Topical Report Amendment 21

Pages 17-15 and 17-21

Marked Copy Showing Proposed Changes

Proposed Pages Pages 17-15 and 17-21

Figure 17-3. Off-Site Organization

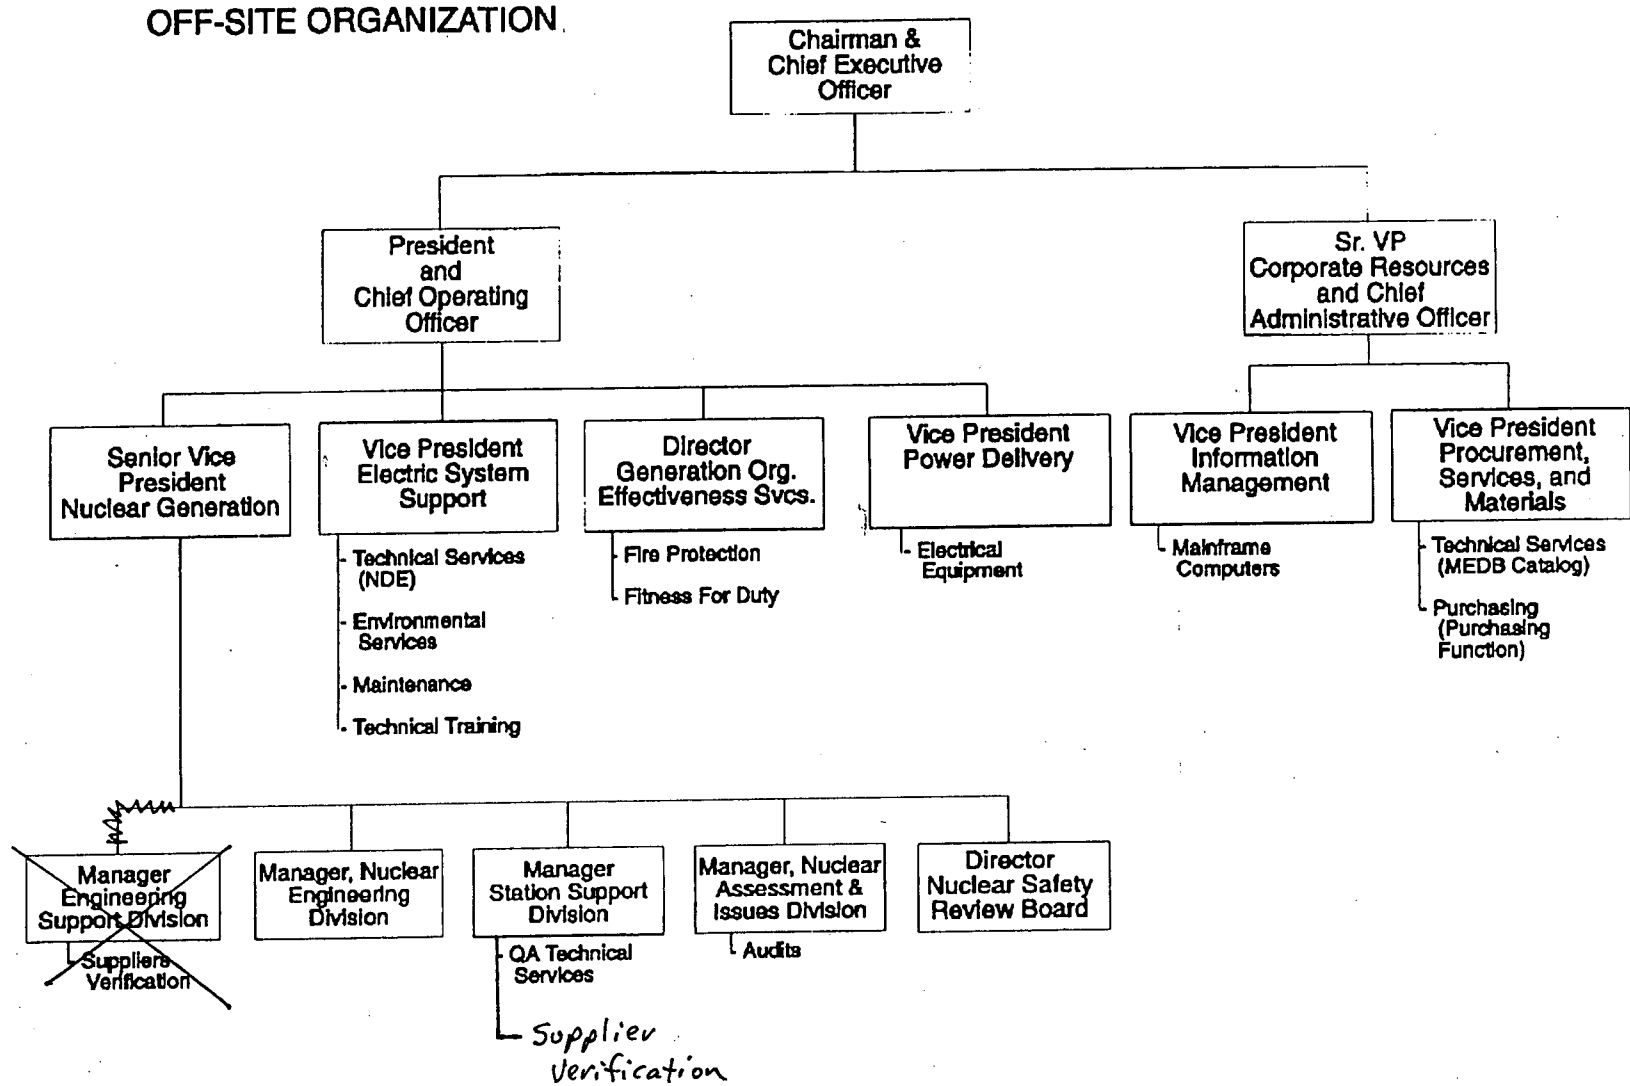
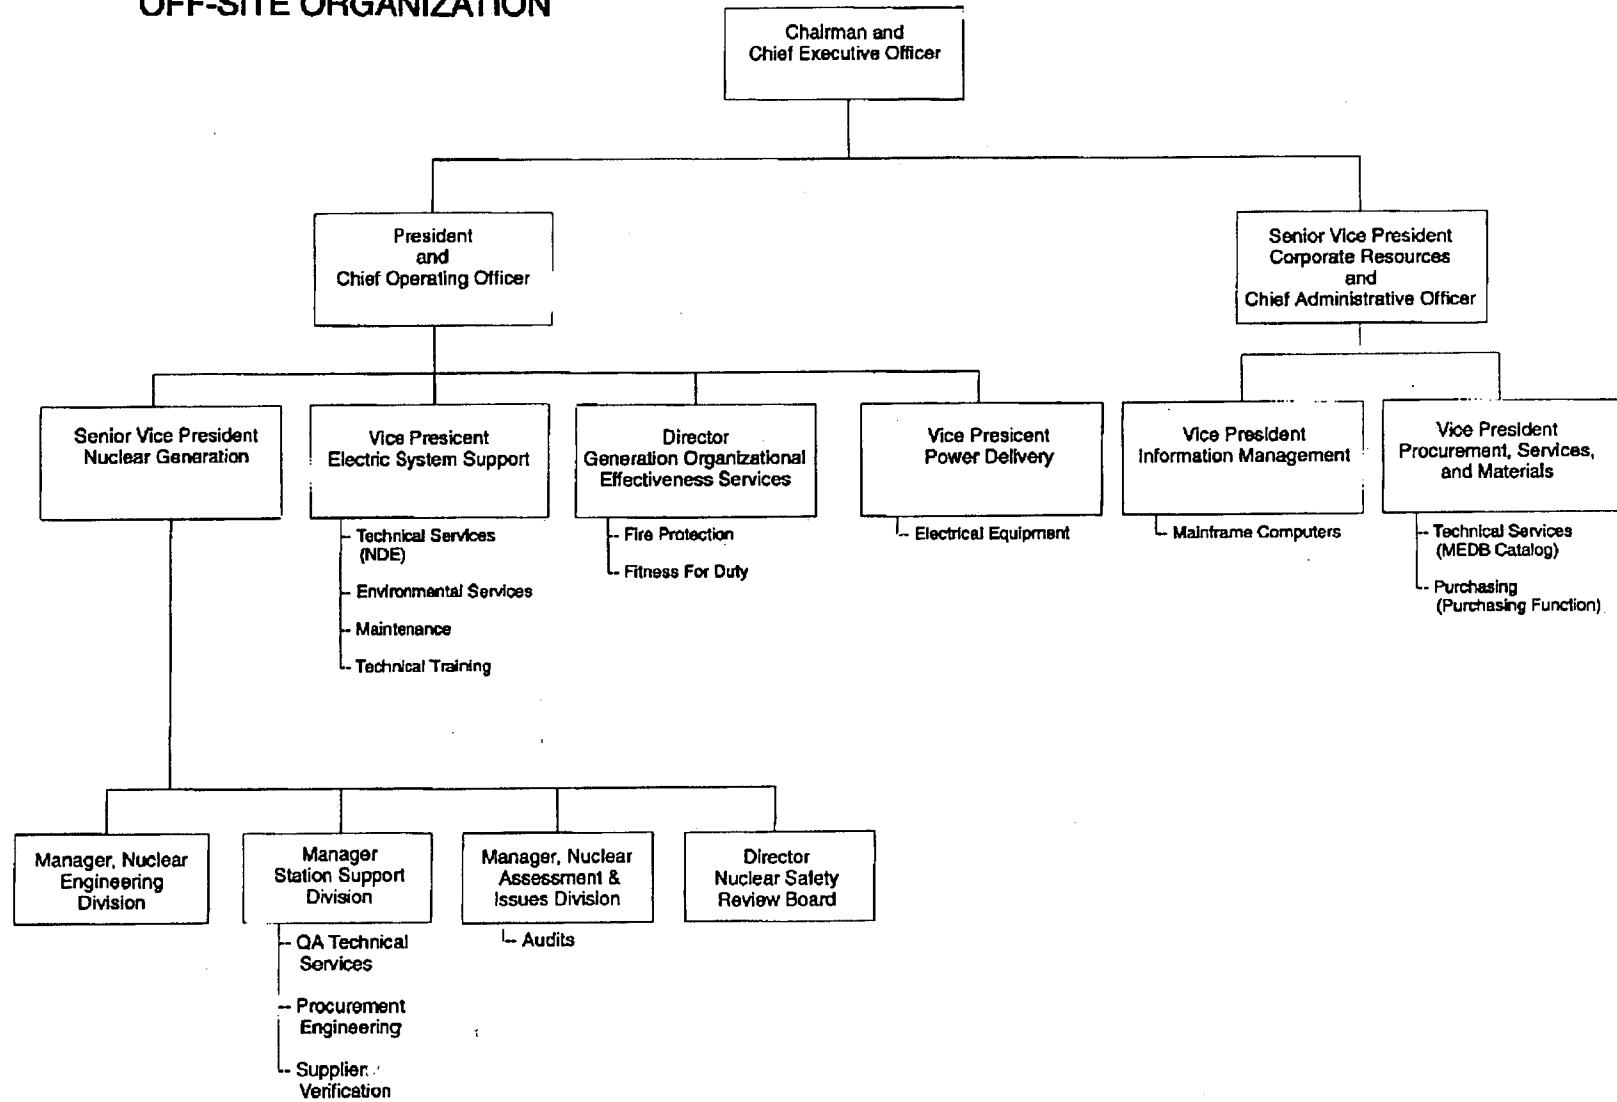
The Nuclear Generation Department, Nuclear General Office, is divided into ~~four~~<sup>three</sup> divisions. The activities of each division are directed by a manager who reports to the Senior Vice President, Nuclear Generation. The divisions within the Nuclear General Office are: ~~(1) Engineering Support, which provides technical support to the stations in procurement, supplier verification, maintenance and engineering;~~ <sup>(1) Nuclear Engineering, which provides support to the stations in severe accident analysis, safety analysis, nuclear design, and fuels/core management;</sup> ~~(2) Station Support, which provides technical support to the stations in work control and human performance, chemistry, radiation protection, steam generator maintenance, quality assurance services, inservice inspection and special projects such as license renewal, RM&C, and steam generator replacement;~~ <sup>(2) Station Support, which provides technical support to the stations in work control and human performance, chemistry, radiation protection, steam generator maintenance, quality assurance services, inservice inspection and special projects such as license renewal, RM&C, and steam generator replacement;</sup> and ~~(3) Nuclear Assessment and Issues, which provides technical and business support to the stations in operating experience assessment, operations assessment, business/financial support, regulatory/industry affairs, NSRB,~~ <sup>(3) Nuclear Assessment and Issues, which provides technical and business support to the stations in operating experience assessment, operations assessment, business/financial support, regulatory/industry affairs, NSRB,</sup>

The Nuclear Generation Department, Nuclear General Office, is divided into three divisions. The activities of each division are directed by a manager who reports to the Senior Vice President, Nuclear Generation. The divisions within the Nuclear General Office are: 1) Nuclear Engineering, which provides support to the stations in severe accident analysis, safety analysis, nuclear design, fuels/core management, procurement engineering, and supplier verification; (2) Station Support, which provides technical support to the stations in work control and human performance, chemistry, radiation protection, steam generator maintenance, quality assurance services, inservice inspection, maintenance, and engineering, and special projects such as license renewal, RM&C, OAC replacement, and steam generator replacement; and (3) Nuclear Assessment and Issues, which provides technical and business support to the stations in operating experience assessment, operations assessment, business/financial
